Determination 2021/006

Compliance with Building Code Clause G13 Foul water of an effluent field that is part of a domestic foul water treatment system at 17 Rua Road, Mangawhai

This determination considers the compliance with Building Code Clause G13 Foul water of an effluent field that is part of a domestic foul water treatment system. The determination discusses the slope, stability and size of the disposal field.

Figure 2: The foul water treatment system and relevant features (Draft figure only)

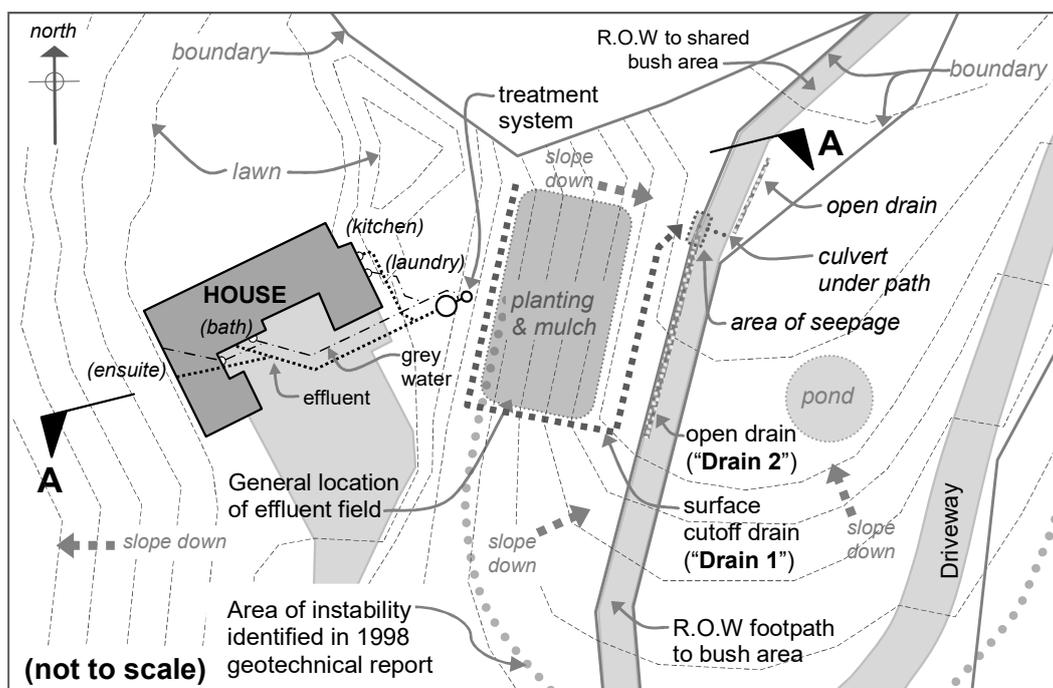
2.2.3 Figure 2 shows details of the owner’s foul water treatment system including the effluent field. This figure also indicates approximate contours and areas of previous instability as identified in the 1998 geotechnical report.

Figure 3: View north along the path – the effluent field is within the planted area left of the boundary fence (image taken from the expert’s report)

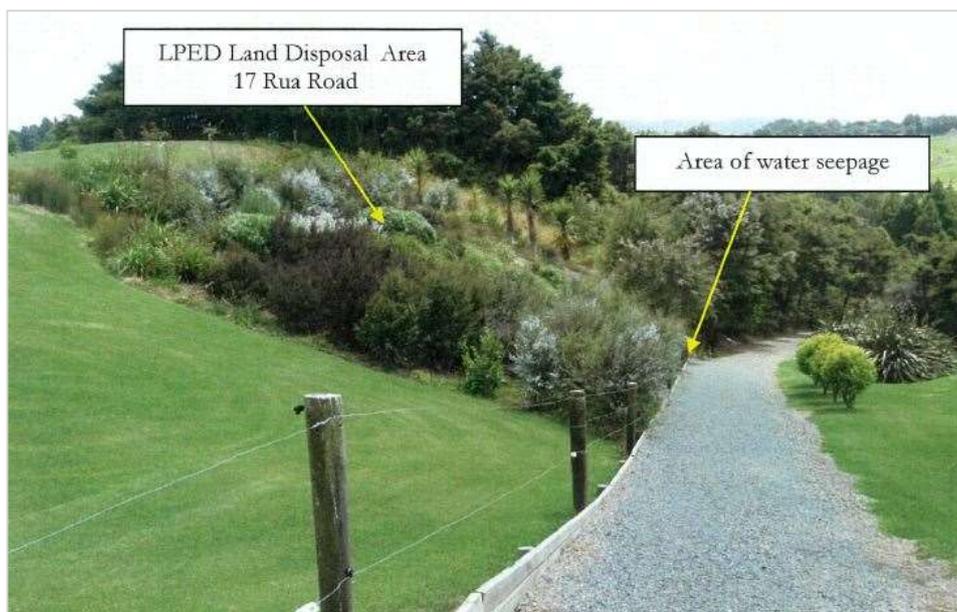
2.3.1 The effluent field is located on a slope about 5-6m from the owners’ eastern boundary (refer to Figure 3). The expert measured the degree of slope where the field is located at approximately 24-27° (44-51%).
